Revision Number	Date	Drawn	Details of Issue / Revision
P01	19/05/23		Response to RFI
P01	29/04/22		Issued for Planning

**Project Details:**  
 Dalguise  
 Monkstown

**Drawing Title:**  
 Proposed GA Plans - Block D

# BLOCK D

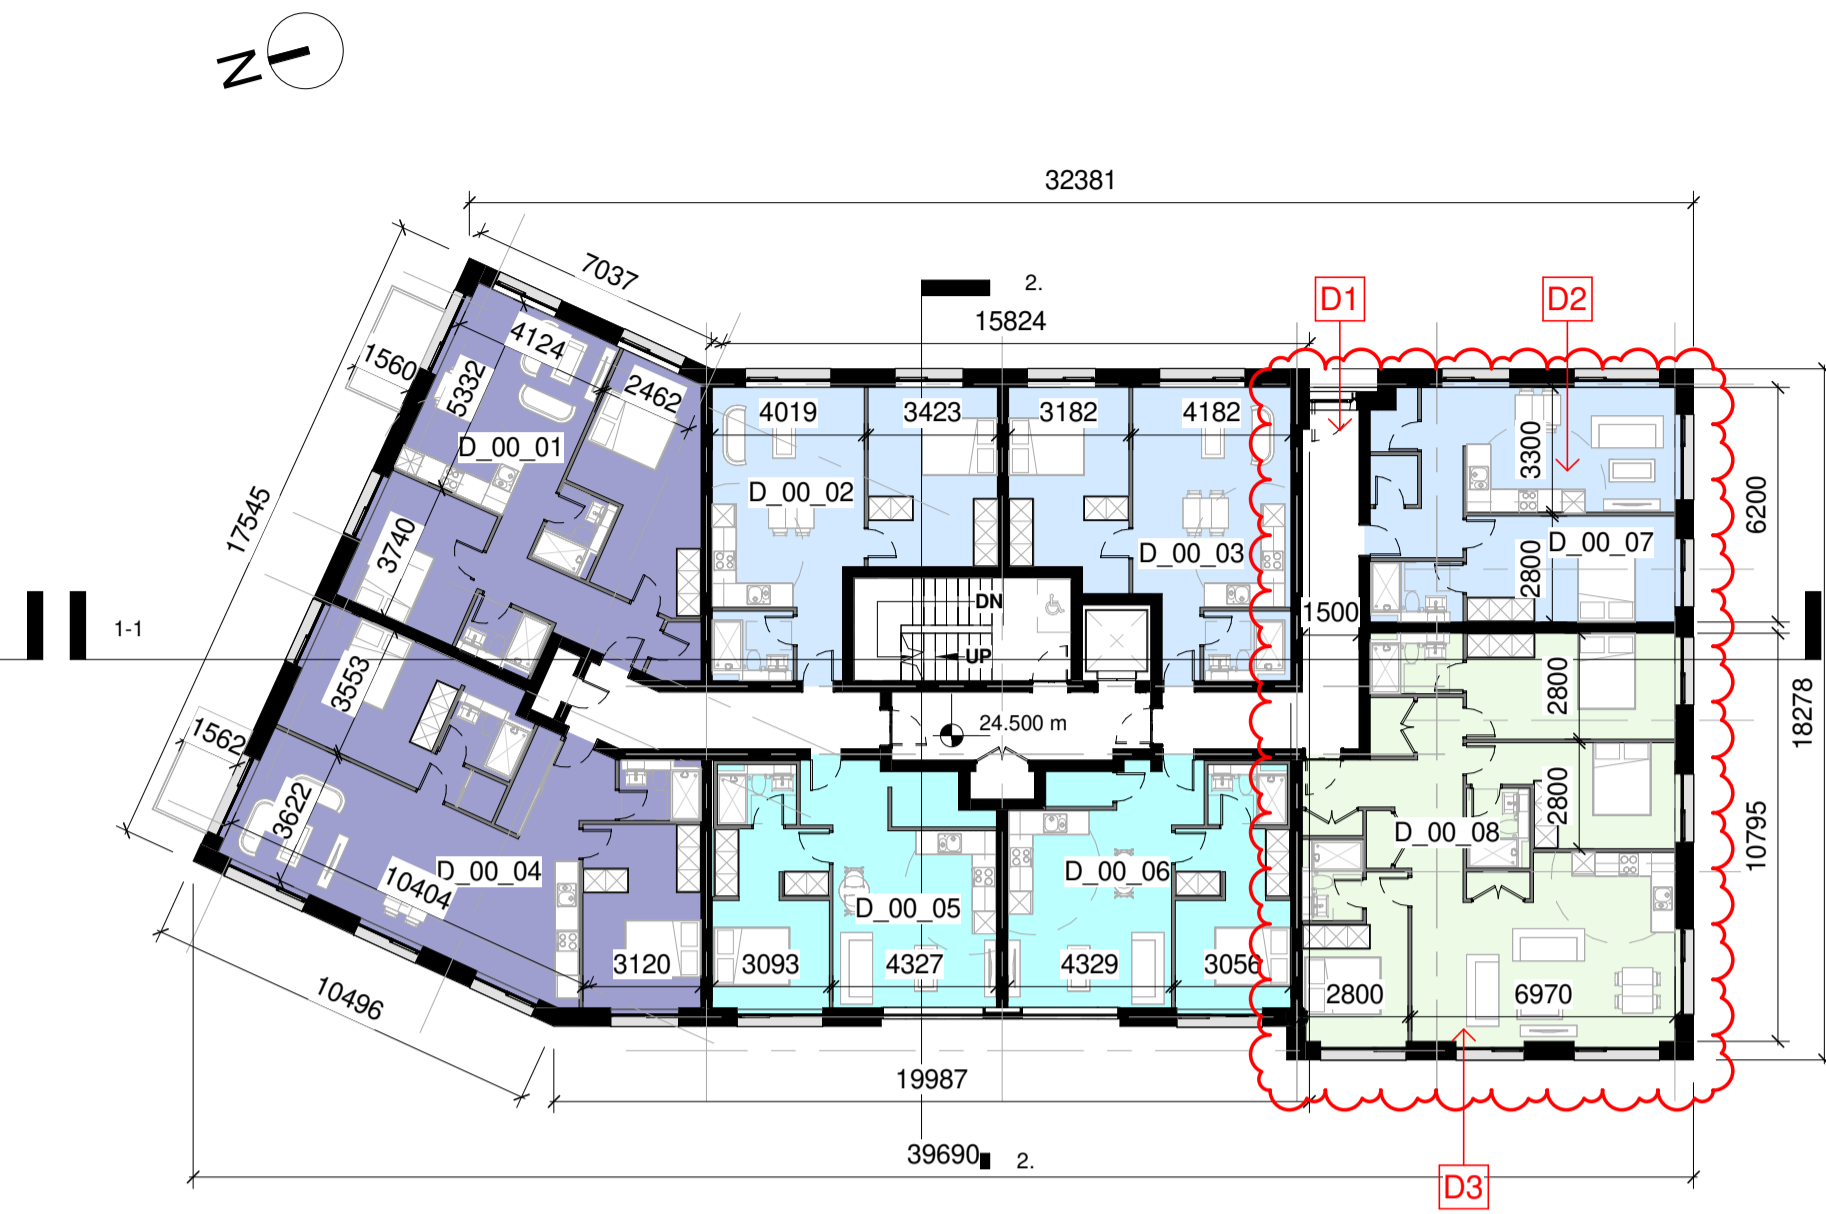
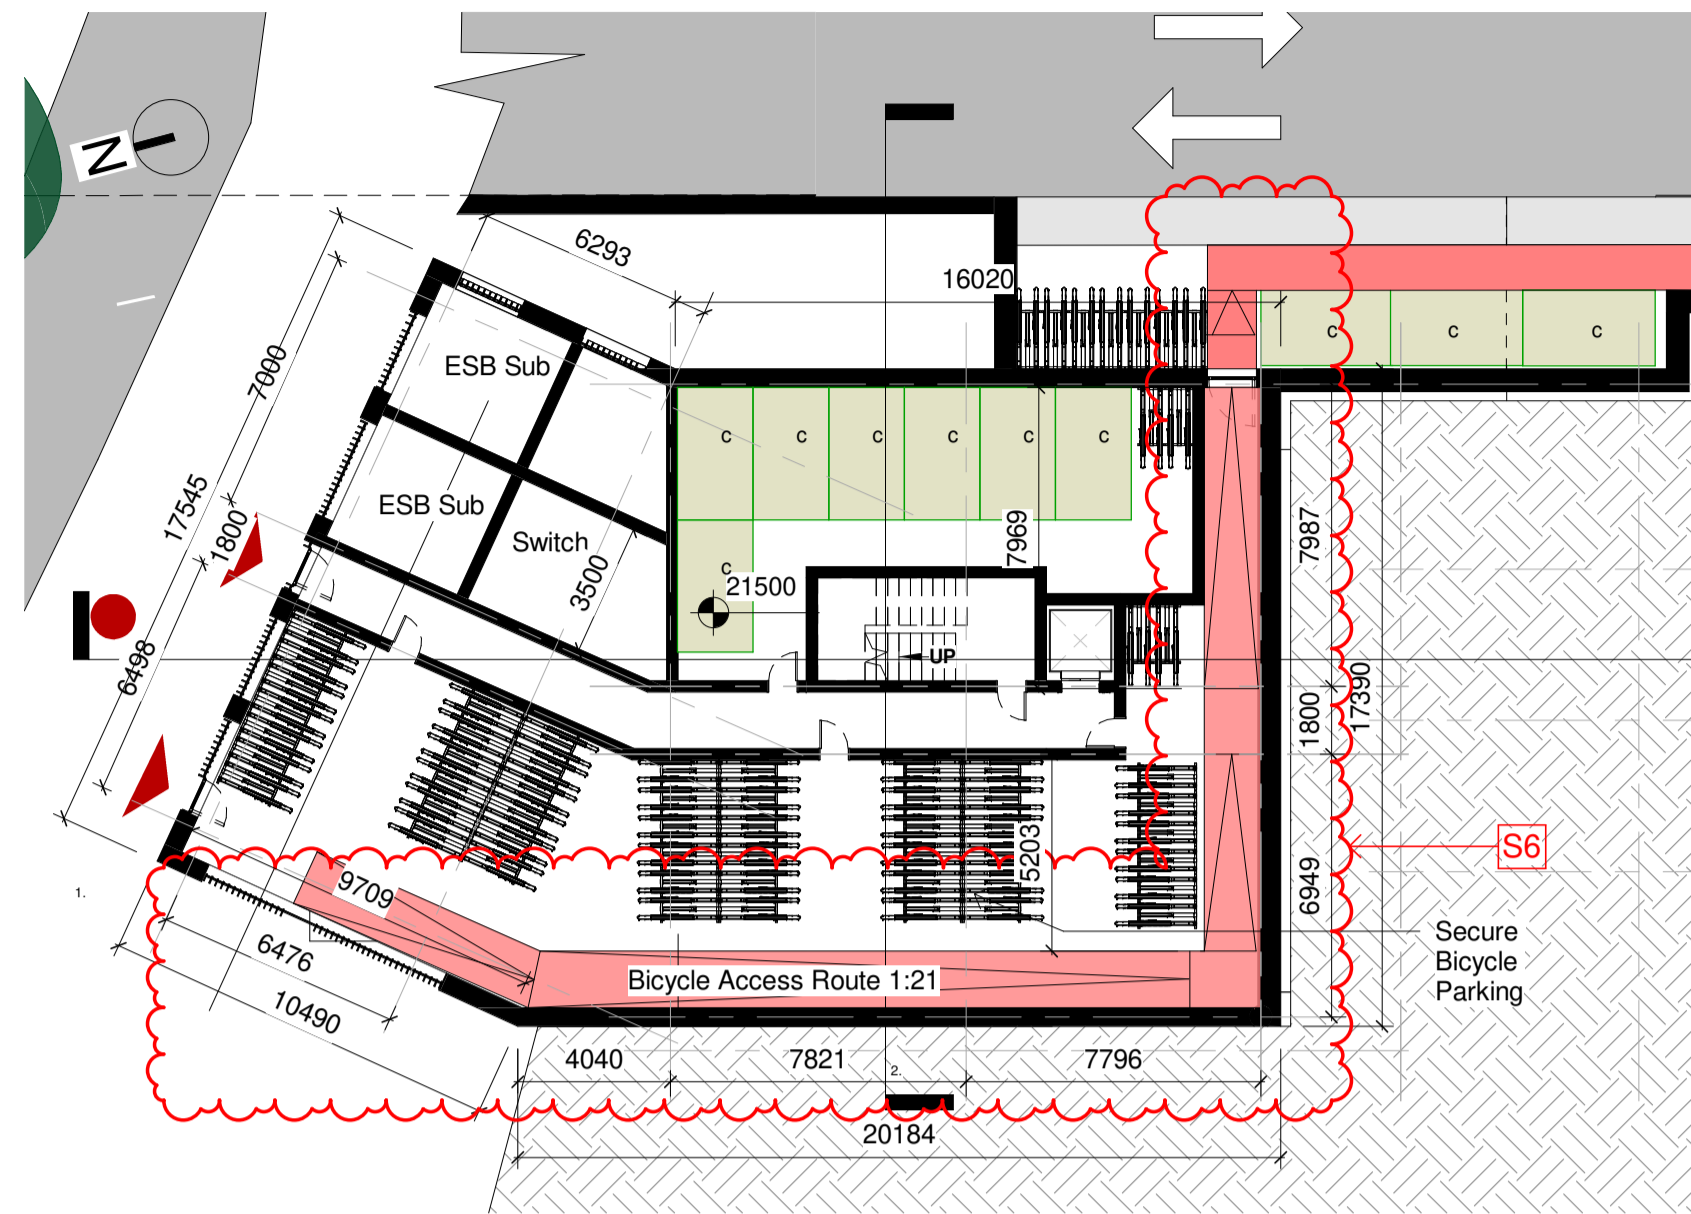
- D1. New Entrance added.
- D2. New 1 Bed Apartment added in lieu of Car Park Entrance Ramp.
- D3. New 3 Bed (5p) Apartment added in lieu of Car Park Entrance Ramp.
- D4. Minor alterations Roof Profile
- S6. Bicycle Entrance Widened with new separate access cycle route to Basement cycle stores
